Presentation to PLUS Committee South Lake Union Rezone December 13, 2012

South Lake Union Community Coalition

Mayor's Proposal

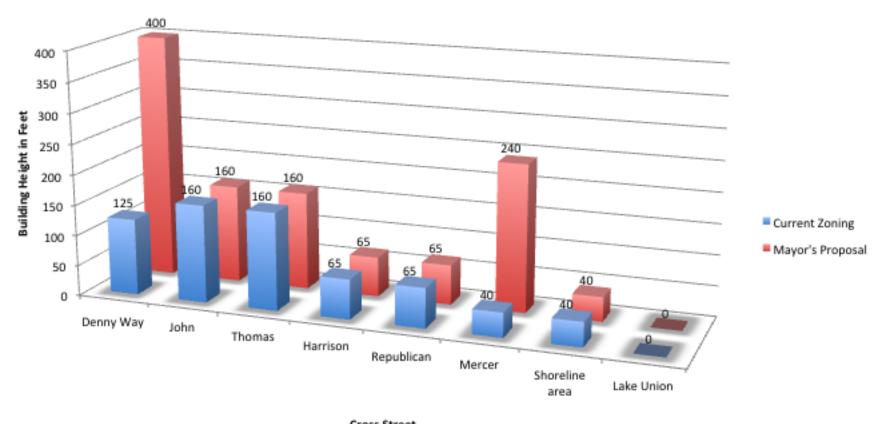
Mercer/Valley blocks surrounded by lower height buildings

Birdseye View to the South Comparison

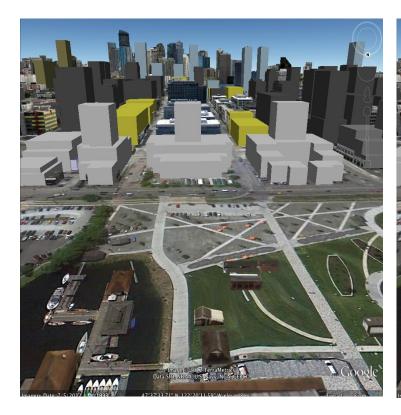
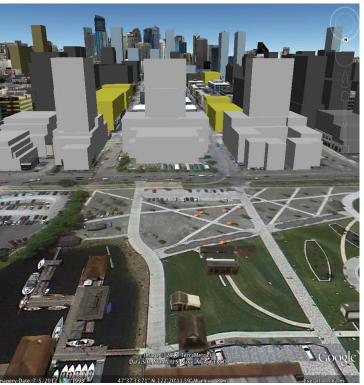
160' 8000 sq. ft. Towers

240' 10500 sq. ft. Towers
